**PLANNING COMMISSION MEETING STAFF REPORT**

**DATE OF MEETING:** July 17, 2017  
**NAME OF PROJECT:** Midway Springs  
**NAME OF APPLICANT:** Watts Enterprises  
**AGENDA ITEM:** Master Plan of Midway Springs  
**LOCATION OF ITEM:** 600 North 200 East  
**ZONING DESIGNATION:** R-1-15

**Subject: Midway Springs, Preliminary and Master Plan Approval**

WATTS ENTERPRISES  
MIDWAY SPRINGS  
PRELIMINARY  
PHASING PLAN

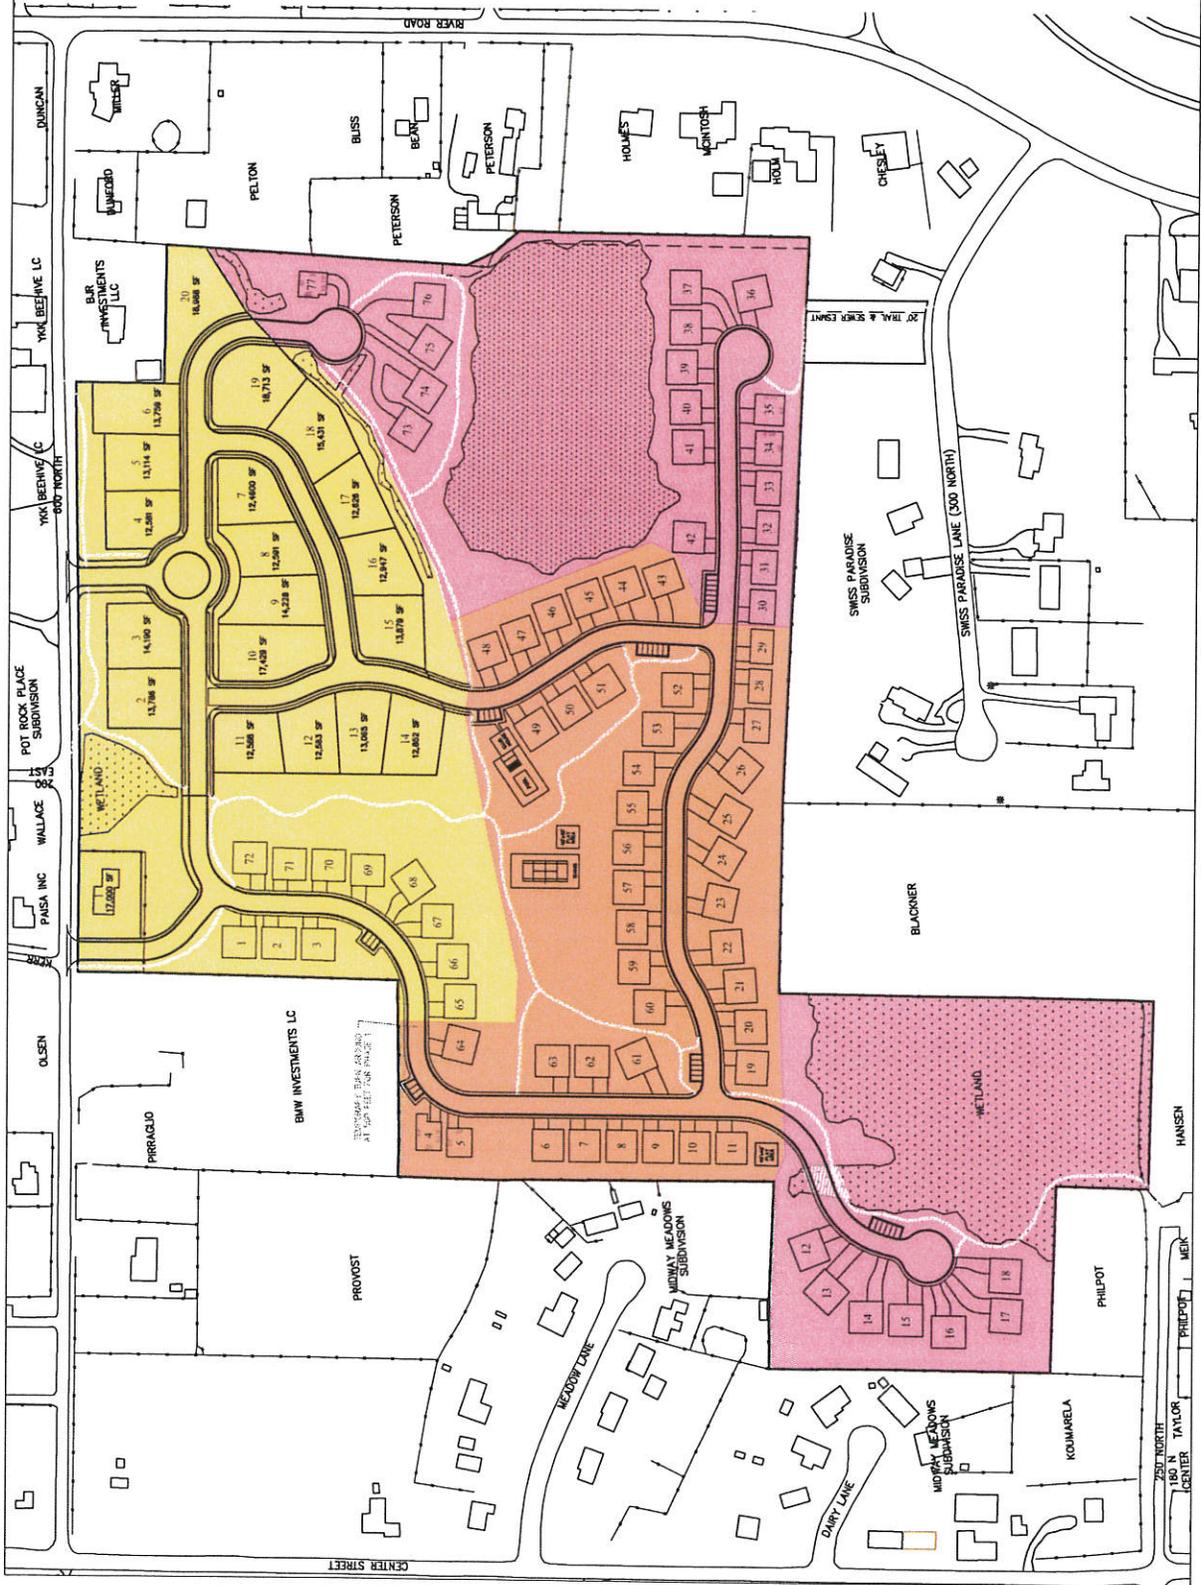
The Land Use Code requires that a Master Plan request must demonstrate that approval of the project in multiple phases can occur such that the project can still function autonomously if subsequent phases are not completed. Therefore, the Master Plan application must demonstrate that sufficient property, water rights, roads, sensitive lands protection, and open space are proposed with the first phase to allow the project to function without subsequent phases.

At this point it is unknown if the Midway Springs phasing plan does meet the requirements. More information is needed to assure that the open space acreage per phase has been met. Also, the development does need to receive a recommendation from the Water Board regarding the amount of water the development will need to tender to the City. Both items will be discussed later in this report.

*Open Space* – The code requires that with each phase that is approved there is enough open space to comply with the requirements of the code. For example, phase I must have at least 50% open space for that particular phase. If phase I has 75% open space then phase II only needs to have 25% open space as long as both phases are equal in acreage. The development application does not include an acreage total of open space per phase. It is unknown if each phase meets the minimum requirements as required by the code. The overall total of required open space does comply with the requirements of the code.

*Access* – Each phase of the subdivision must meet the access and cul-de-sac limitation requirements of the code. A cul-de-sac is limited to 500' in length, unless approved otherwise by the City Council. Staff has reviewed the phasing plan and all street length and access requirements have been met as presented in the application.

WATTS ENTERPRISES  
 MIDWAY SPRINGS  
 EXISTING CONDITIONS /  
 SENSITIVE LANDS MAP

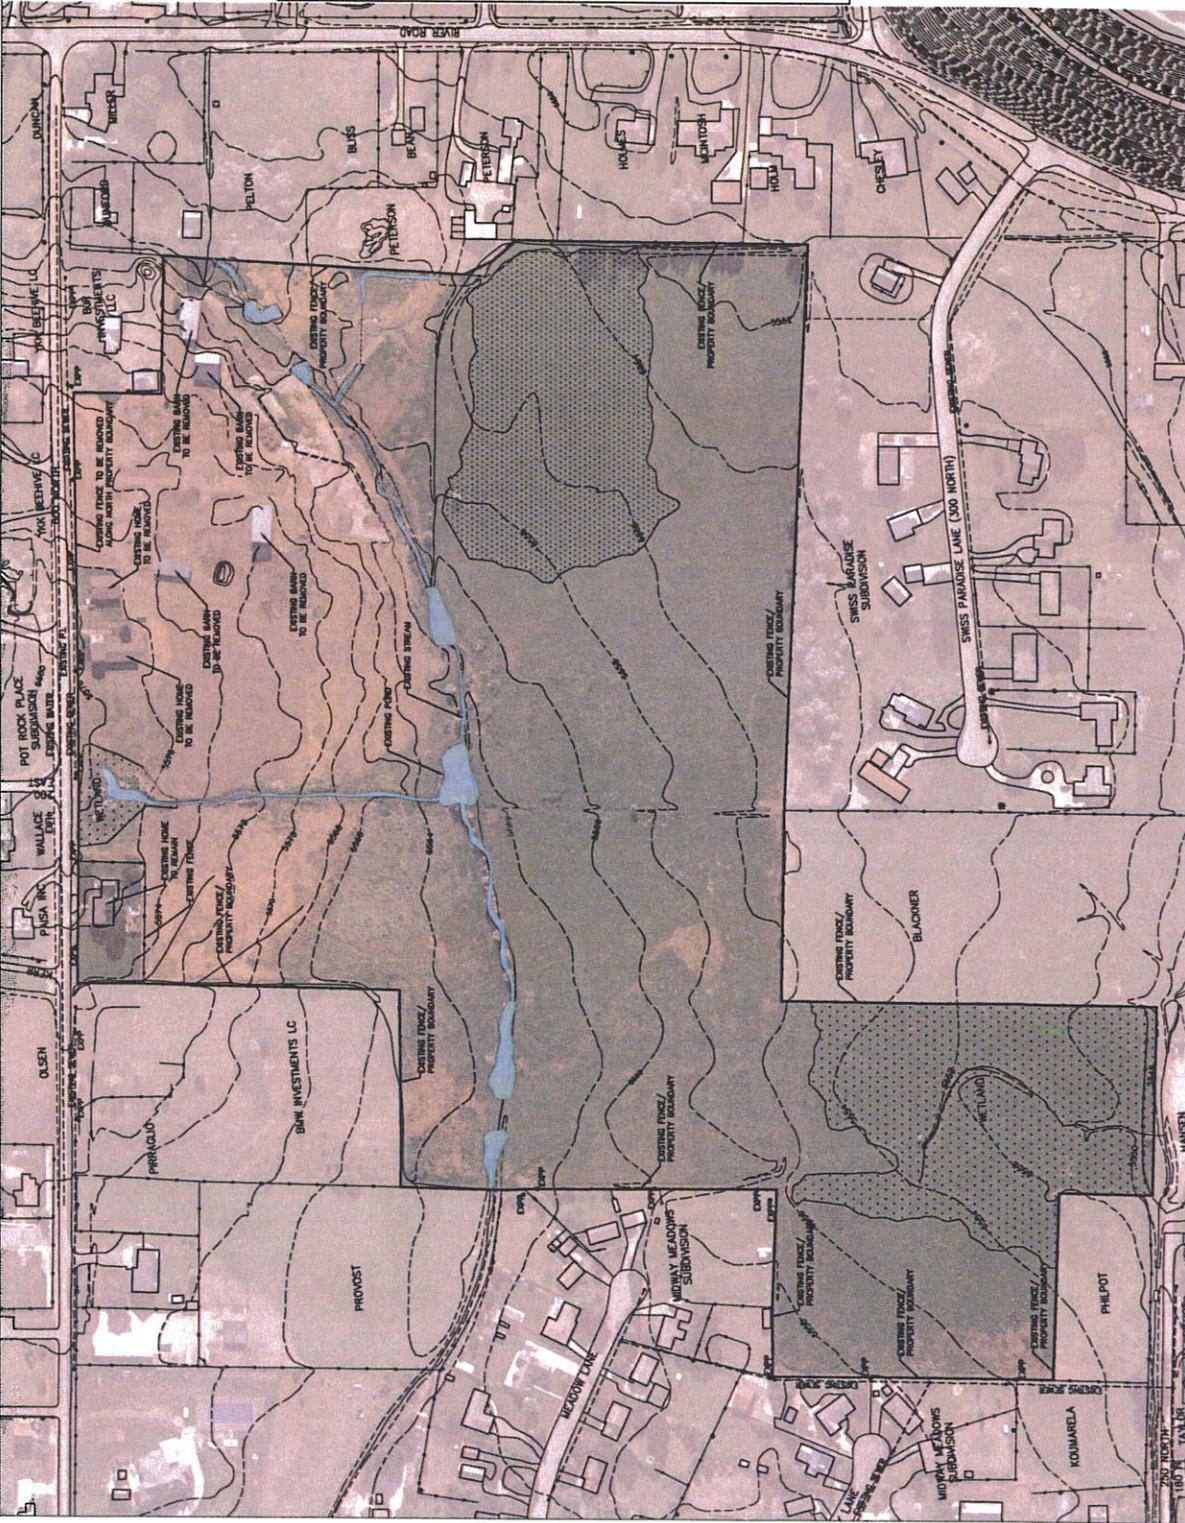
*Sensitive Lands* – The property does contain some wetlands that will not be disturbed through the development process. The wetlands will become part of the open space for the development and will be preserved. There is a stream/ditch that runs through the property. It will be impacted by the roads crossing the development because of the culverts that will cover the ditch. Midway Irrigation Company owns an easement to the ditch area and will need to approve modifications made to the current ditch. There is a hot spring on the property that will be preserved also. There are also acres of wetlands on the property that are included in the open space areas of the development. A study has been submitted by the developer and will be reviewed by three organizations that include The Army Corps of Engineers, Horrocks Engineers, and another third-party wetland expert that will be decided by the City. There is concern by residents and of the area and the City regarding the location of wetlands and therefore the City has decided to have three entities review the study that has been submitted.

- Per the provided wetland delineation, performed by BIO-WEST, 8.2 acres of wetlands were identified. The US Army Corps of Engineers has provided a Preliminary Jurisdictional Determination. The wetlands delineation should be reviewed by a second wetlands professional. The wetland delineation report is currently being reviewed by our wetland professional in our Pleasant Grove office. His findings will be reported in the meeting.
